**NUMBER:** 08-074-20 REV. E

**This bulletin supersedes Technical Service Bulletin 08-074-20 REV. D, date of issue November 17, 2020, which should be removed from your files. All revisions are highlighted with **\*\*asterisks\*\*** add photo.**

Improved Steering Feel

2018 - 2020	(JL)	Jeep Wrangler
2020	(JT)	Jeep Gladiator

Fig. 1

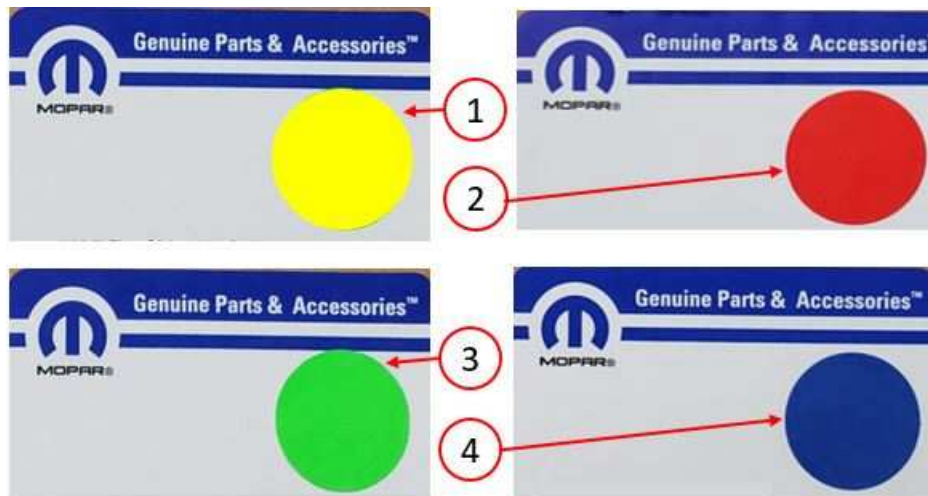
**\*\*The Steering Gear Parts Label Has A Color Dot On It To Help Confirm The Correct Steering Gear Was Order**

- 1 - Yellow Dot, 68507576AA (JT)
- 2 - Red Dot, 68507569AA (JL 4 Door, **W/O EXJ 3.0 Diesel**)
- 3 - Green Dot, 68507574AA (JL 4 Door, **With EXJ 3.0 Diesel**)
- 4 - Blue Dot, 68507571AA (JL 2 Door)\*\*
